UNITED STATES PATENT AND TRADEMARK OFFICE

Office Action Summary	Application No. 10/526,458	Applicant(s) OPPER, REINHOLD	
	Examiner Flemming Saether	Art Unit 3677

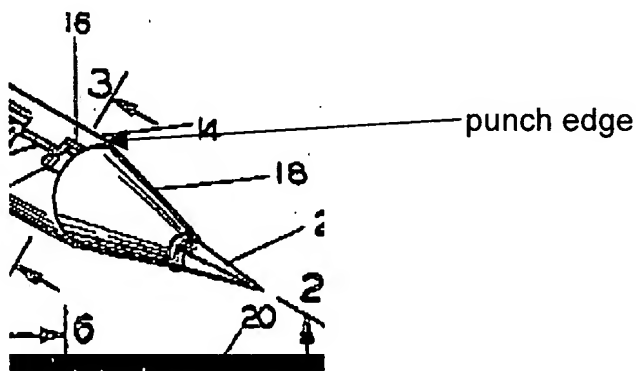
Claims 1-3, 5, 8, 10, 11, 14-16 18, 20, 22, 23, 26 and 27 are rejected under 35 U.S.C. 102(b) as being anticipated by Tendler (US 3,398,627). Tendler discloses a blind rivet (A) comprising a hollow shank (9-11) having a sethead (4), a deformation segment (see Fig. 8) and a connection segment for connecting to a foot (19) of a

mandrel (21). The shank includes an end face (20, 28) having an outer periphery which meets the outermost periphery of the shank to form a punch edge (see below) and the mandrel forms a protrusion (28) at the center of the end face though an open end of the shank. The end face is shown to be overall smooth with a conical (at 20) and pyramidal (at 28) surface and is circular in cross section (see Fig. 3). The mandrel includes a widened head and the other end is inherently hardened by the formation of the threads and pointed tip.
